Group:	Service Manual Update
Bulletin No.:	SB-15-002
Issue Date:	1/9/2015

**Subject: CORRECTION OF WORKSHOP MANUAL FOR 2013 - 2015MY
(REVISION OF TROUBLESHOOTING PROCEDURE FOR THE DTC P2123)**

HINO 155, 195, 155h, 195h, 238, 258, 268, 338, 358

CONTENTS:

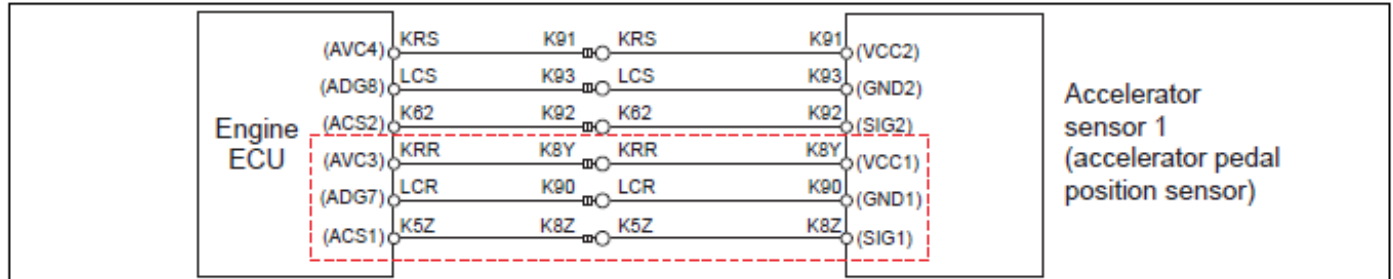
Troubleshooting information and Inspection procedure of the DTC/ P2123 were revised.
